VENDOR SUBMITTAL REVIEW

HIGHWAY SAFETY CORP.		GLASTONBURY, CT	
ITEM 525.33 - BRIDGE RAILING - NETC 2 RAIL		DRAWN: MHM	
PROJECT No. 1M-091-1(36)		CHECKED: [Signature]	
TOWN OF HARTLAND		DATE: 5-28-03	
INTERSTATE ROUTE 91 BRIDGE No. 38		SCALE: 1/8"=1'-0"	
STATE OF VERMONT WINDSOR COUNTY		HSC REFERENCE NO.: 1354	
GENERAL CONTRACTOR: [Blank]		SIZE: D REVISION: 0	
SUB CONTRACTOR: F.R. Lafayette, Inc.		SHEET NO.: 1 of 3

ELEVATION - NORTH-WEST BRIDGE RAIL
FACING (NW) FROM ϕ OF ROADWAY
PAY LIMIT ITEM 525.33 = 404'-3 3/4"

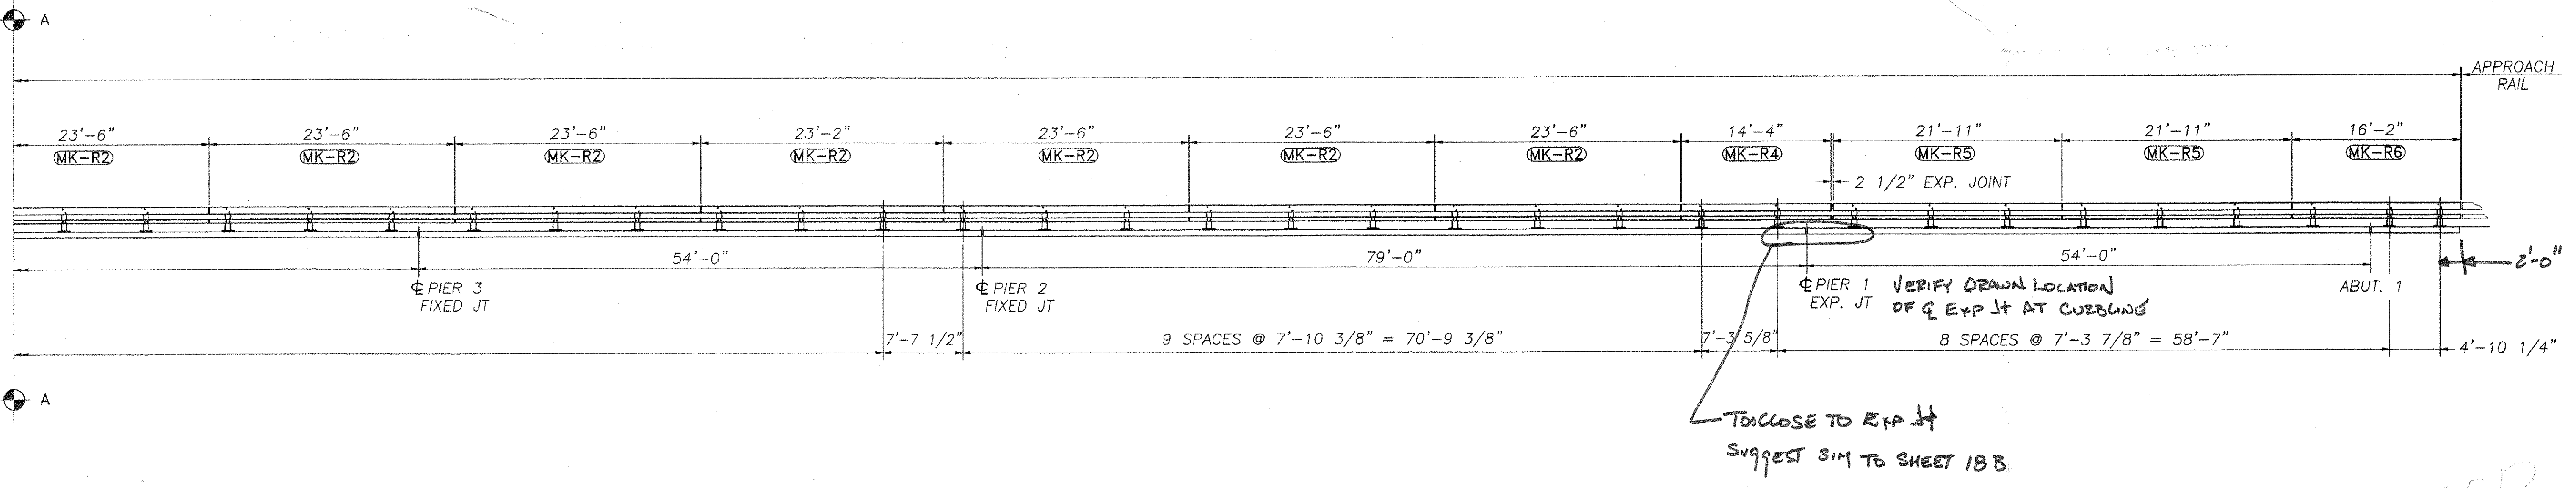
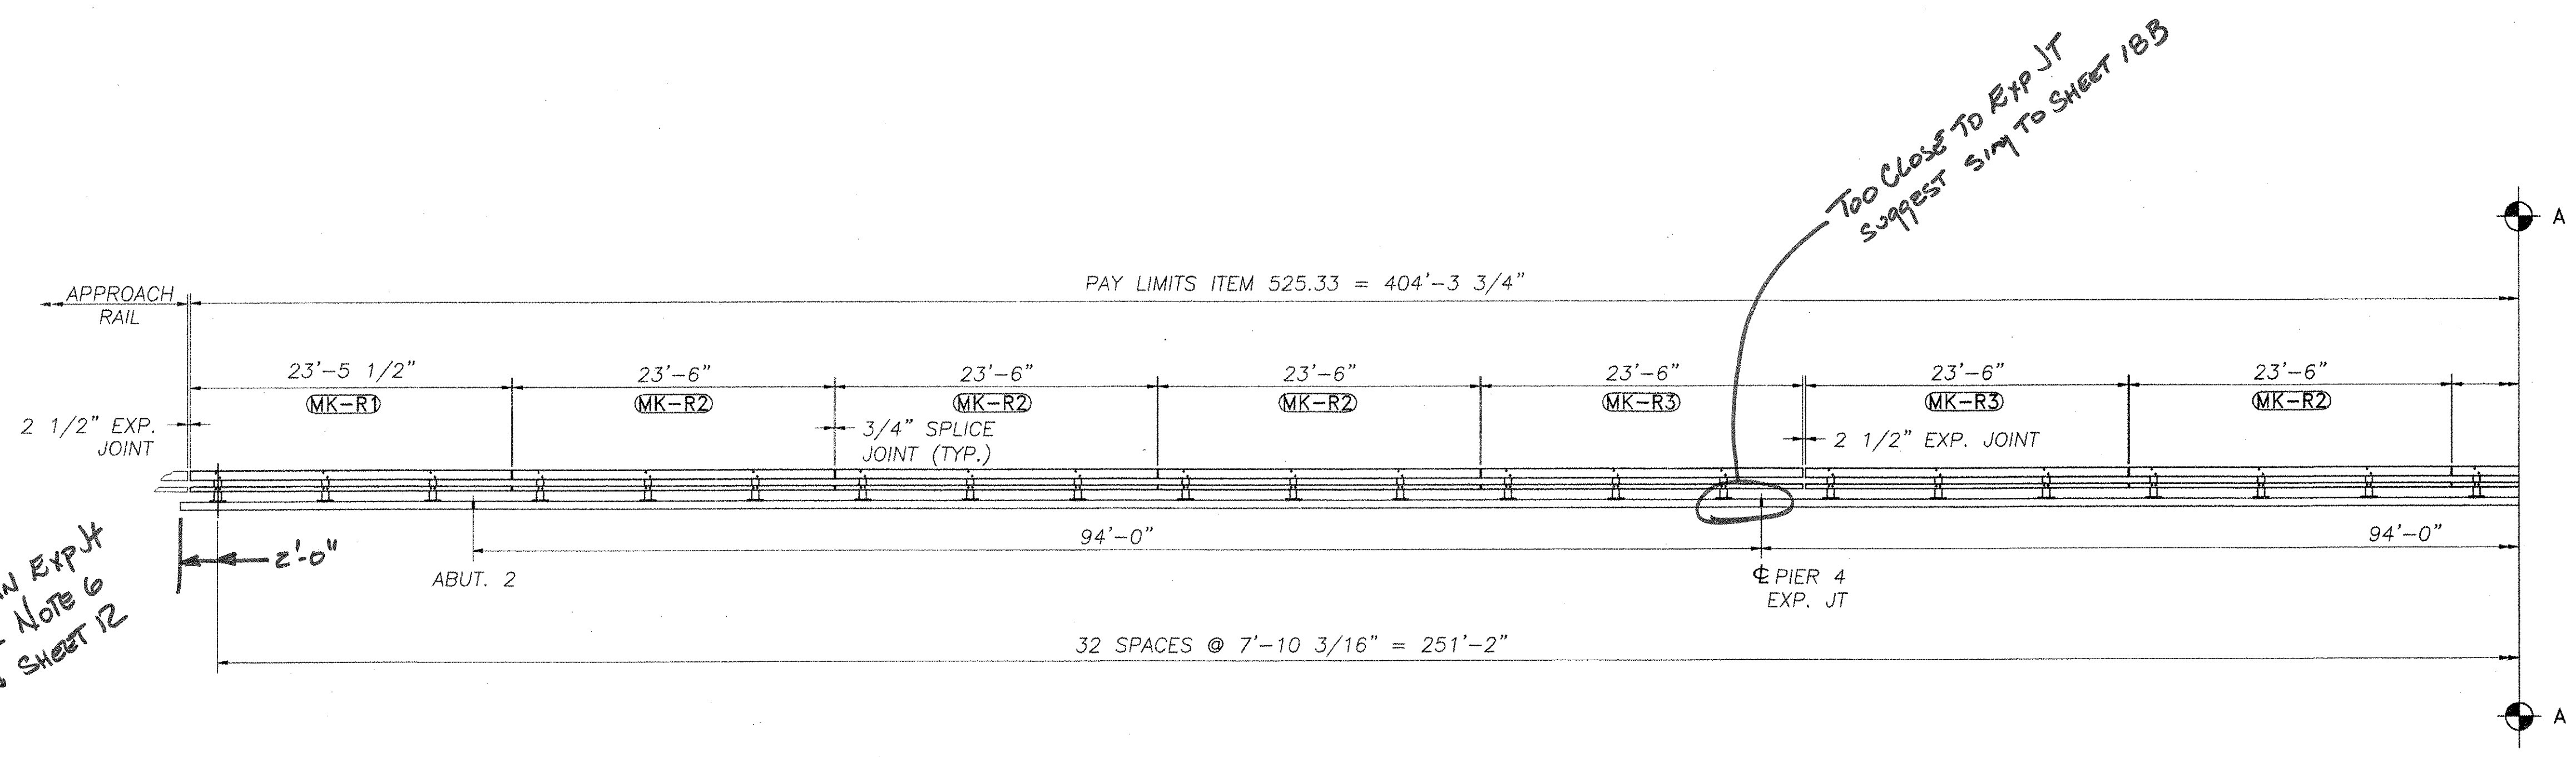
NOT AN EXP JT
PRR NOTE 6
ON SHEET 12

Too Close To Exp JT
Suggest SIM TO SHEET 18B

Too Close To Exp JT
Suggest SIM TO SHEET 18B

SUPERCEDED
